LEXINGTON-FAYETTE URBAN COUNTY GOVERNMENT CONTRACT CHANGE ORDER Page 1 of 11		Date:	October 1, 2025
To (Contractor):		Project:	Clays Mill Road Improvements, Section 1
L-M Asphalt Partners, Ltd.		Location:	CMR - Waco to Harrodsburg
dba ATS Construction		Contract No.	17-2020
3009 Atkinson Ave, Suite 400, Lexington, KY 40509		Original Contract Amt.	\$10,683,653.39
		Cumulative Amount of Previous Change Orders	\$1,373,272.58
		Percent Change - Previous Change Orders	12.85%
		Total Contract Amount Prior to this Change Order	\$12,056,925.97
		Change Order No.	5 - Final
You are hereby requested to comply with the following changes from the contract plans and specification;			
Current Change Order

LEXINGTON-FAYETTE URBAN COUNTY GOVERNMENT CHANGE ORDER				DATE:		October 1, 2025
Change Order #:						5 - Final
CONTRACT #:						17-2020
Project: Clays Mill Road Improvements, Section 1						
You are hereby requested to comply with the following changes from the contract plans and specifications;

Clays Mill Road Improvements, Section 1
Change Order No.5 - Final
Reasons for Porposed Changes

1896 -1898 Clays Mill Road

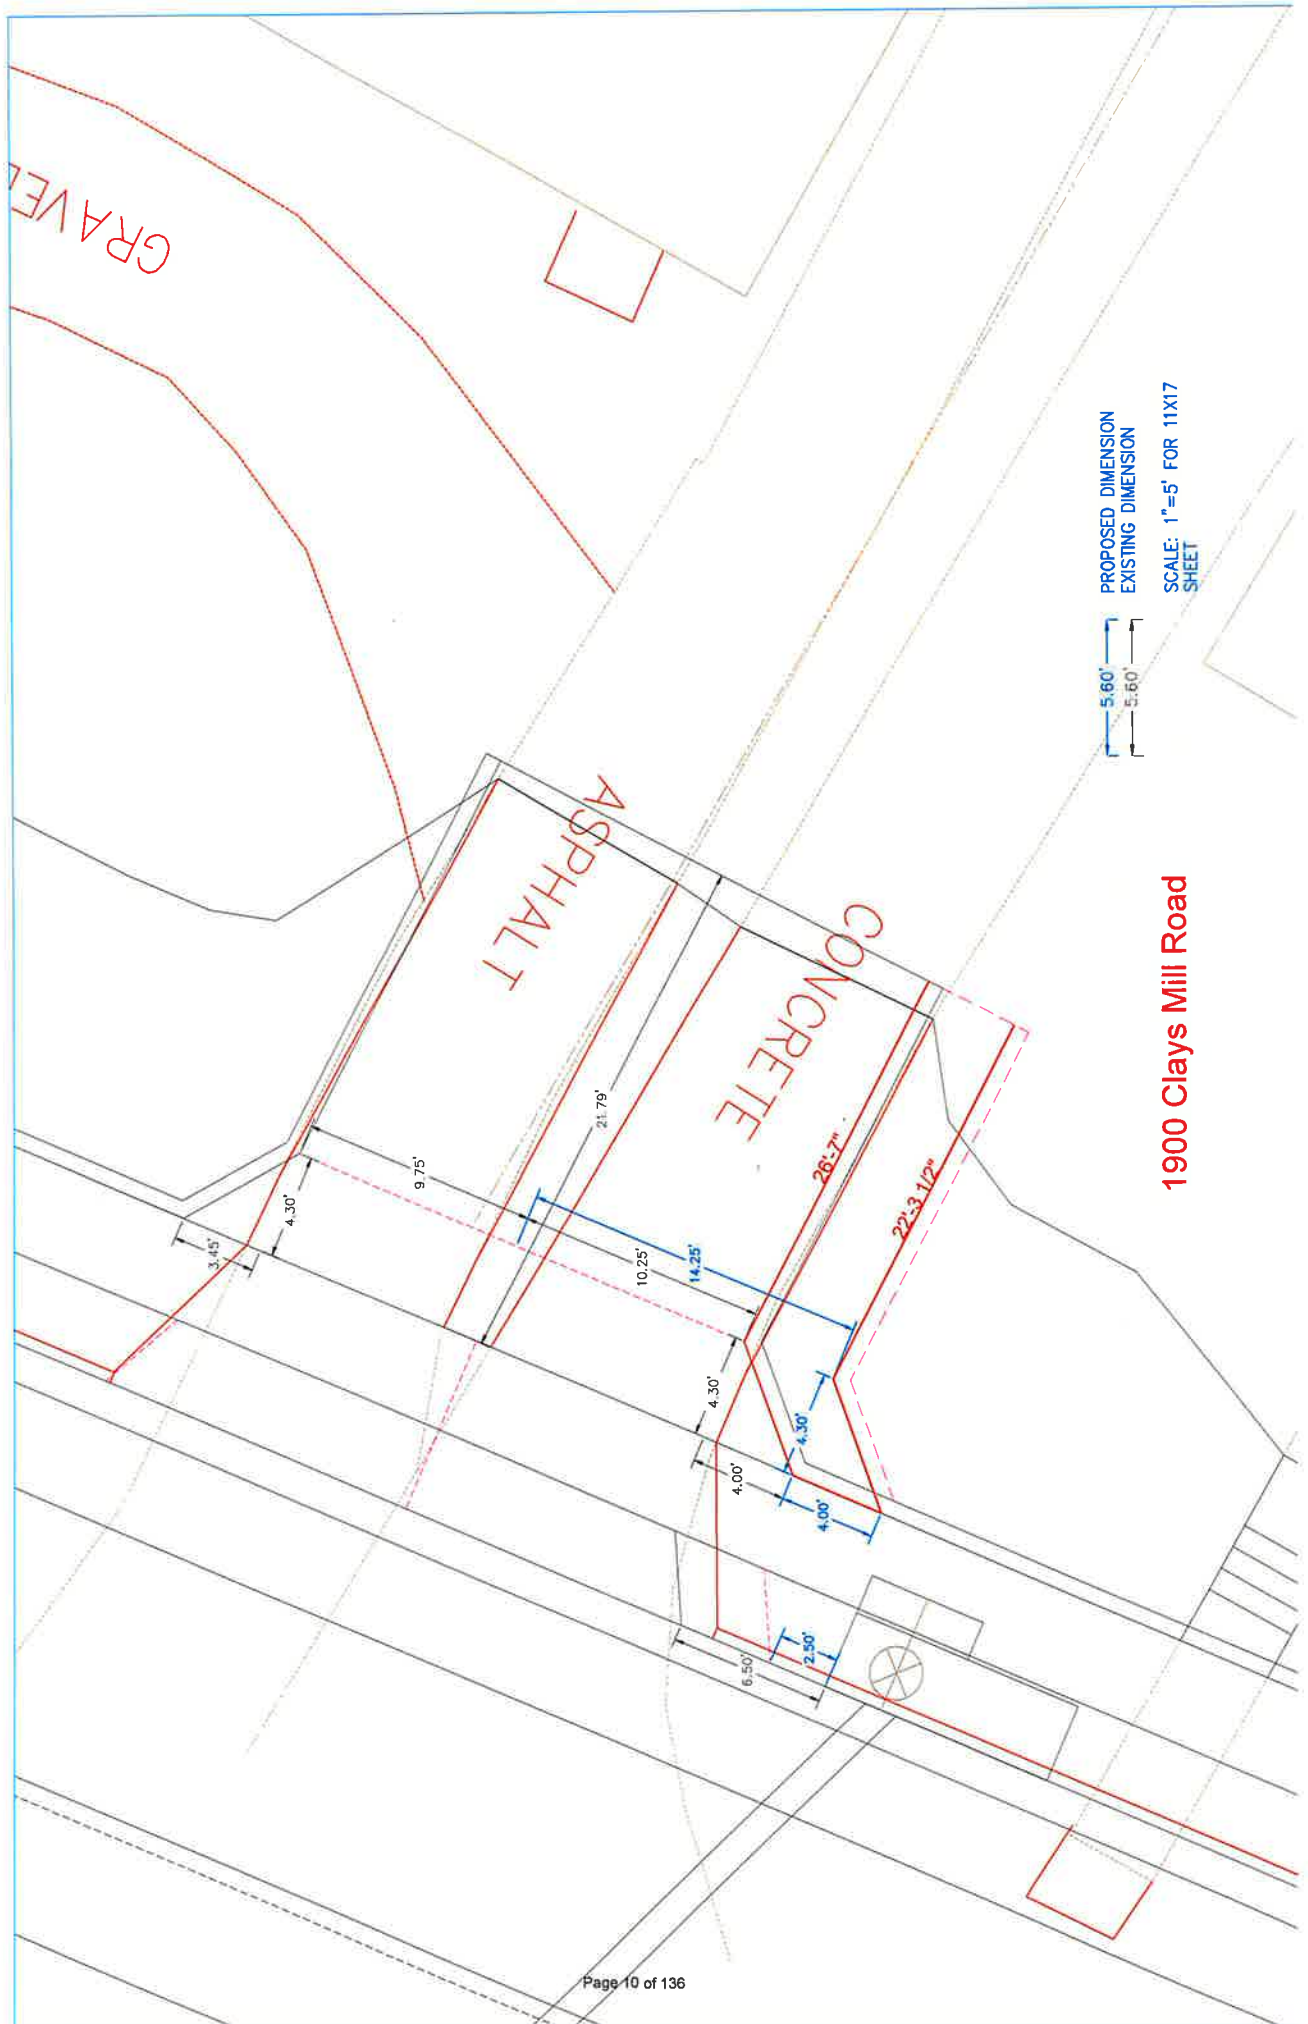
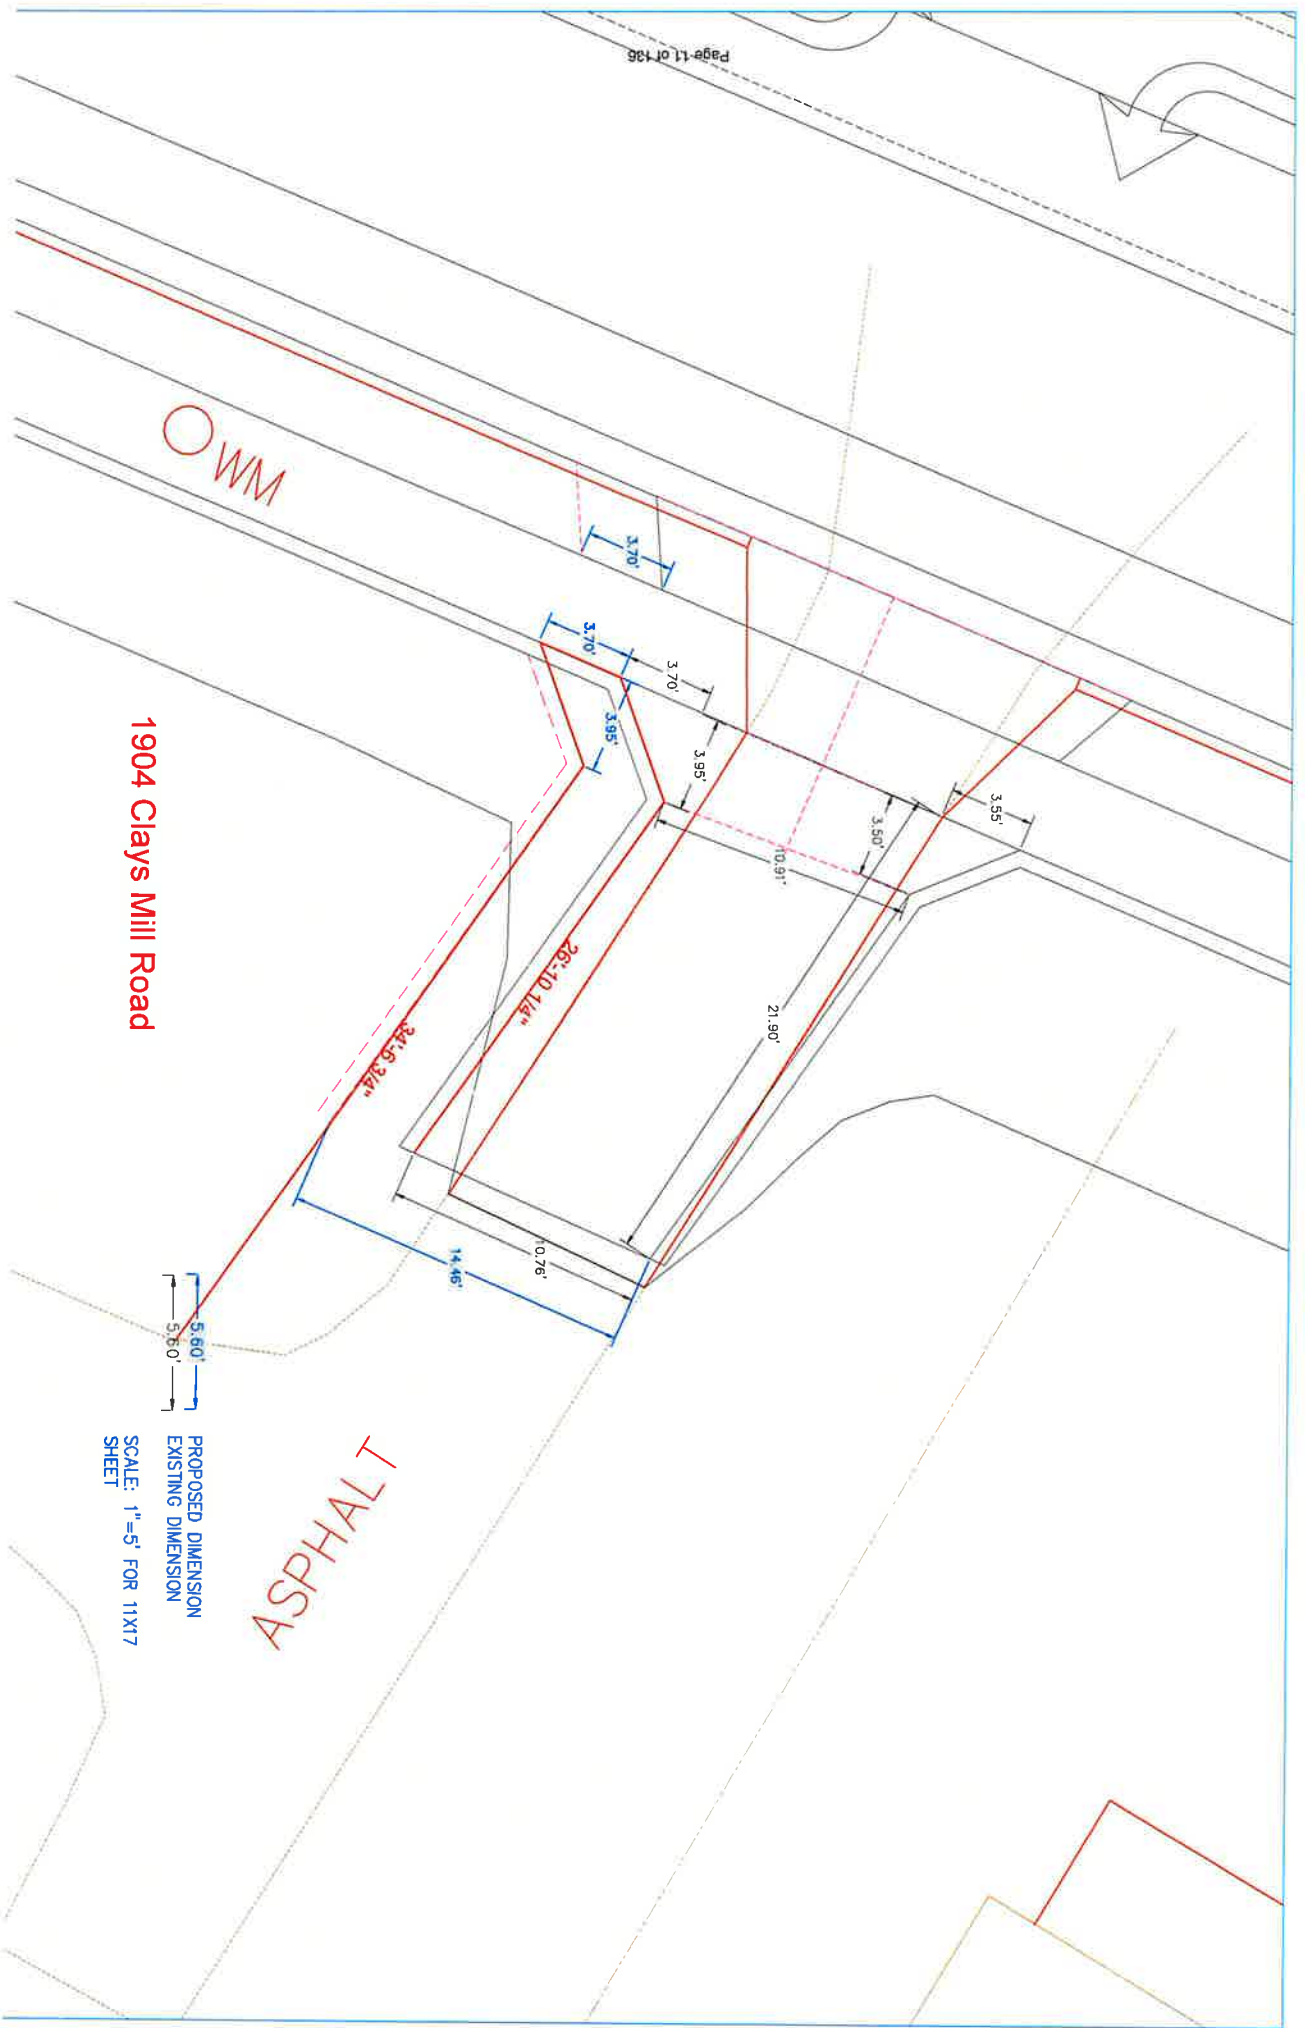
RE: Clays Mill Road Widening
BID NO. 17-2020
Added Retaining Wall Changes (Driveway Improvements)

ADDED Retaining Wall 142 LF @ \$425/LF = \$60,350

1. Adjustments to retaining walls to provide better clearance for vehicles in and out of four driveways. The walls were originally built to the width of the existing driveways. After constructing, property owners complained that they sometimes rub up against the walls because the width is too narrow.
2. Construction of a surface drain and connection to the storm sewer to prevent standing water in a residential driveway. Clays Mill Road was substantially raised in front of this property, resulting in a low spot in their driveway that hadn't existed before. This drain corrects the problem.

Clays Mill Road Lane Allen to Harrodsburg Closures

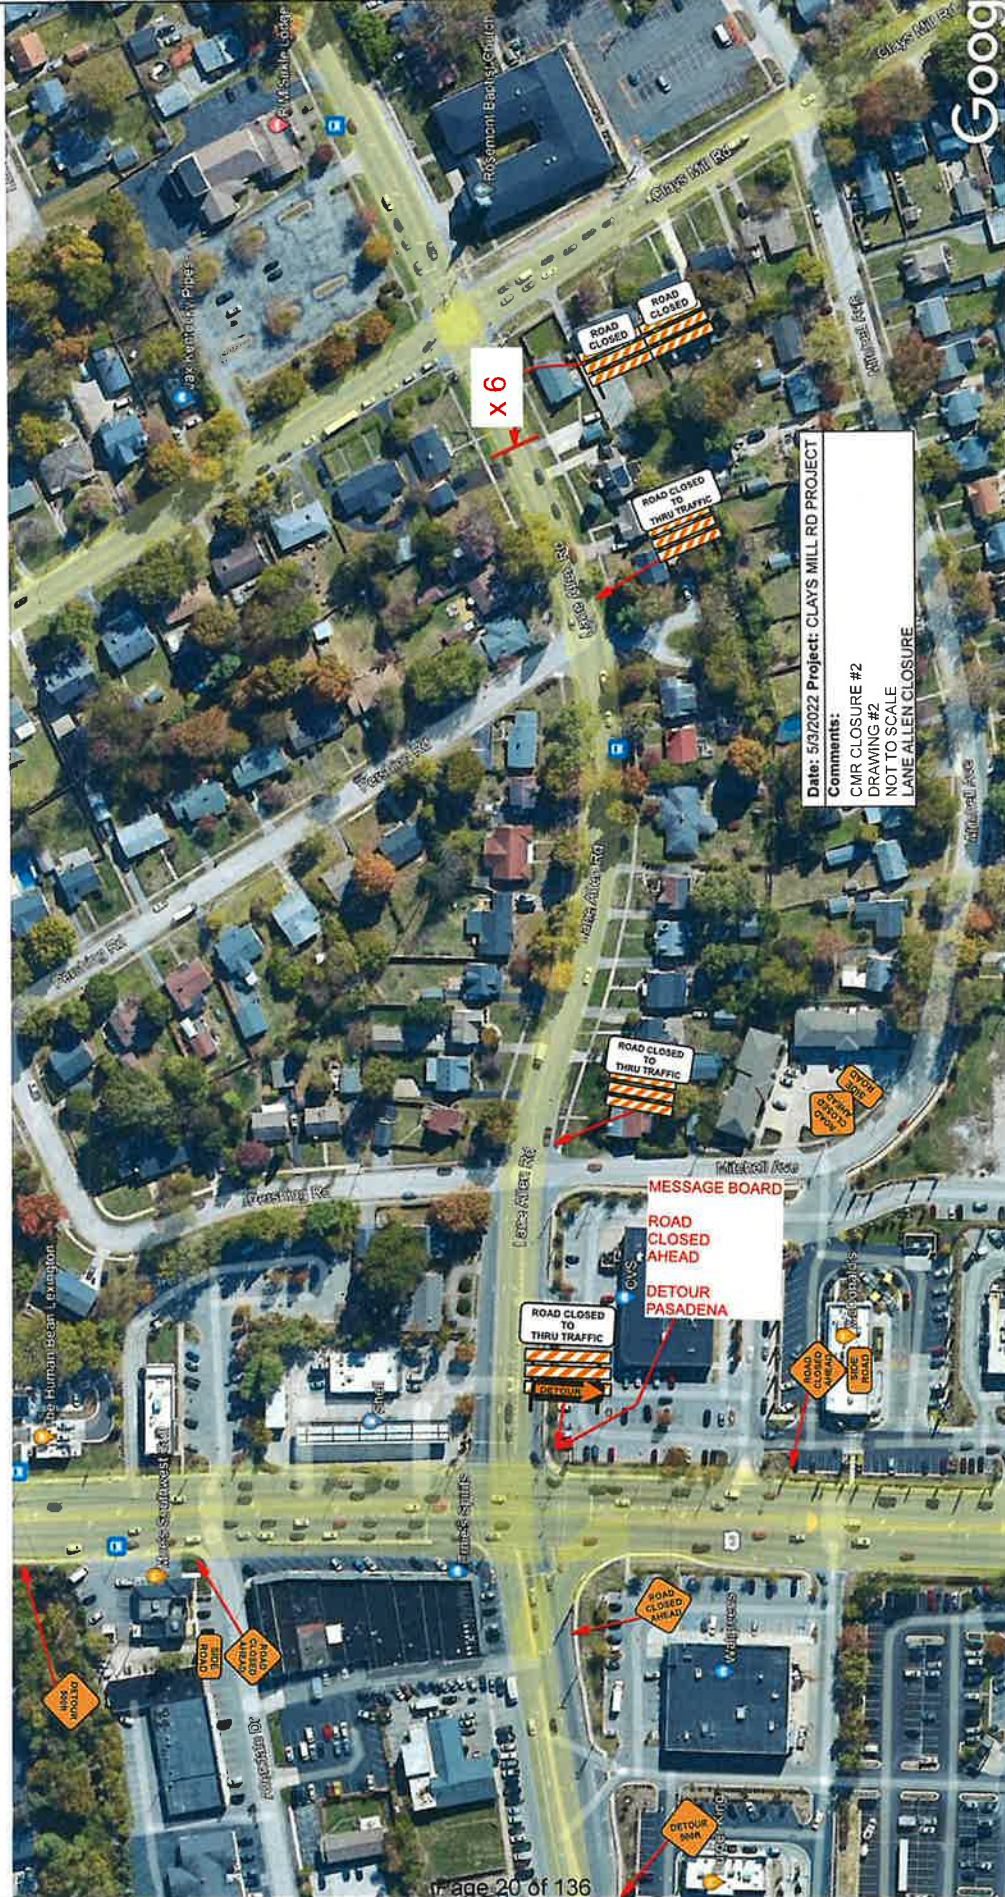
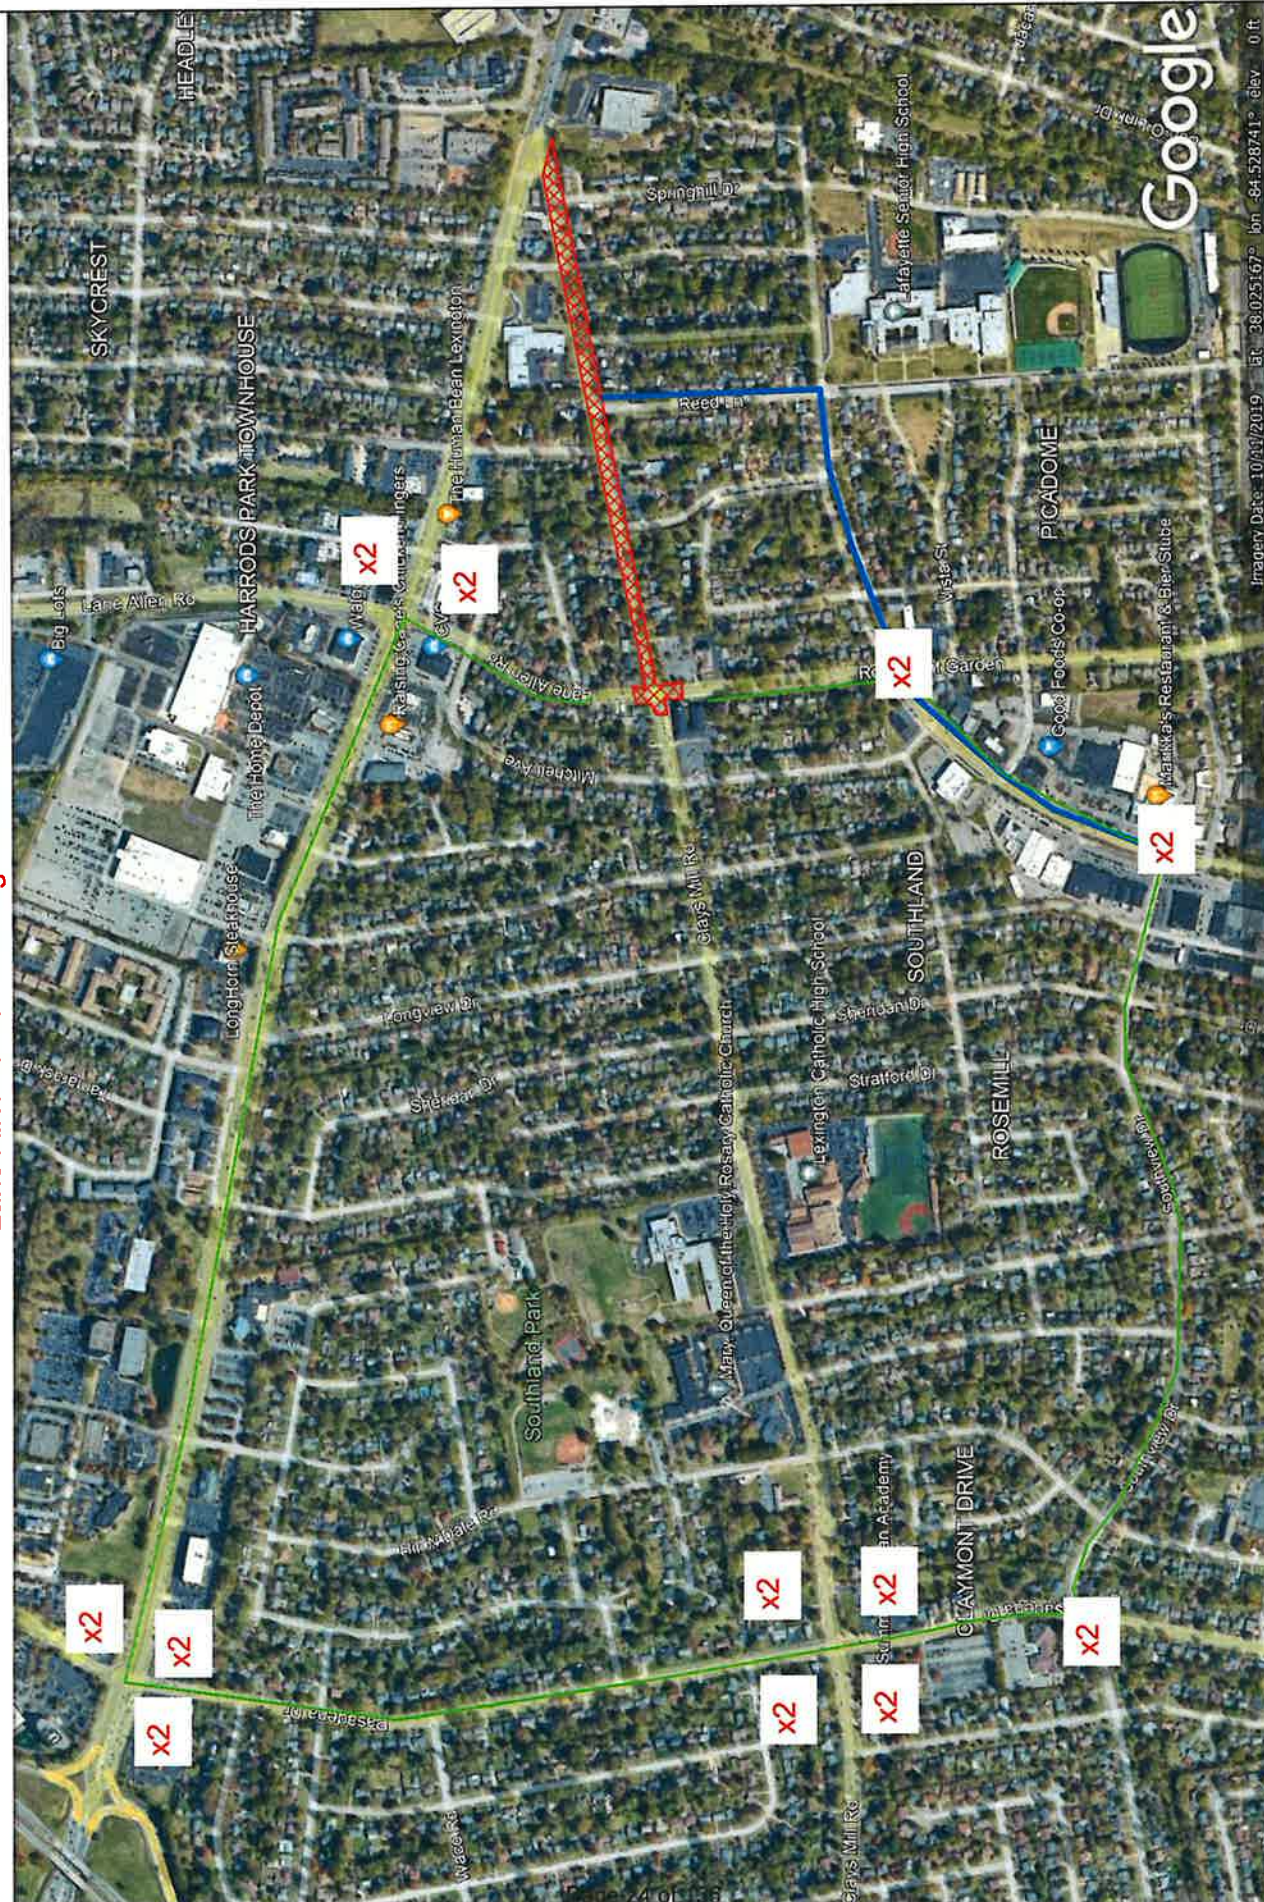
Each one of these utility companies would've had to create/submit/approve their own MOT plan to LFUCG and do their relocations one at a time which would have greatly delayed the construction of the project. Considering the amount of work that had to be done IN the intersection, it was proposed that ATS Construction supply the required traffic control to completely close the intersection to allow each utility contractor to efficiently relocate their facilities in a timely manner and keep construction on the right path. The closure of the intersection lasted approximately two months with the stipulation that it MUST be open when the nearby schools started back in August 2022.

A closure plan was presented and approved by LFUCG and modified throughout the summer to maintain traffic to the best of our abilities. ATS Construction submits the following pricing for Traffic Control Devices provided for this closure. Please note that the unit prices are based on previously approved unit prices for the same items and time frame in Change Order #01.

Figure 1

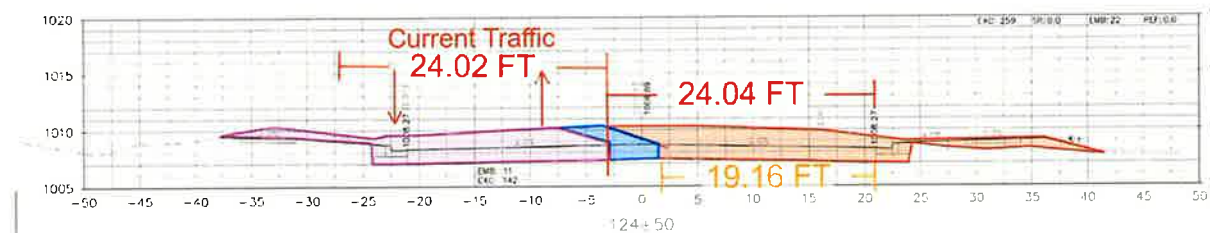
The section from Waco Dr to Pasadena goes through a residential area with several driveways and cross streets. Per the original bid documents, the Maintenance of Traffic plan lays out this area in three construction phases. Phase 1 is to construct various temporary pavement widening left of centerline to push traffic over into two lanes (one each direction). Phase 2, which is the current phase, is to construct everything Right of proposed Centerline including all roadside developments. Phase 3 is to switch traffic to newly constructed phase 2 and construct everything left of centerline. Additionally, the Bid documents state that the contractor is to maintain a minimum of two ten-foot travel lanes for traffic. Adding in minimum widths for striping, the absolute minimum allowed width to maintain traffic would be approx. 22 ft.

As discussed in previous conversations, it appears that the plans did not consider the elevation differences and other constraints that hinder the three-phase traffic plan. Some of these constraints, such as utility pole locations, could not be reasonably foreseen by the designer or the contractor until construction commenced. As it currently stands, the contractor cannot construct this corridor and maintain the required width for the traffic. As a worst-case scenario example, the cross section below (Figure 1) is from STA 124+50. As listed, traffic is currently on existing asphalt and temporary widening with approx. 24 ft of width. To match that width and allow for a 1 ft safety buffer on each side, 24 ft width (from edge of gutter) was used for phase 2 construction analysis. As you can see, to construct 24' width right of centerline, we would actually need to excavate right up to the existing edge of the northbound travel lane (approx. 5 ft LT of CL). While this may be physically possible, we would have a 3 ft dropoff just outside the northbound travel lane and no room for a barrier wall. Further expansion on the diversion is also not possible in this

area as there is a utility pole that already had guardrail put up around it to protect cars from hitting it. Therefore, some sort of safety wedge would have to be put in between the construction and the traffic. Due to the length of the project and some of the depths, a daily safety wedge would not be possible. Because of the items listed above and the need for a safety wedge, construction would have to impede on the Northbound traffic to build enough width to move traffic onto the newly constructed pavement.
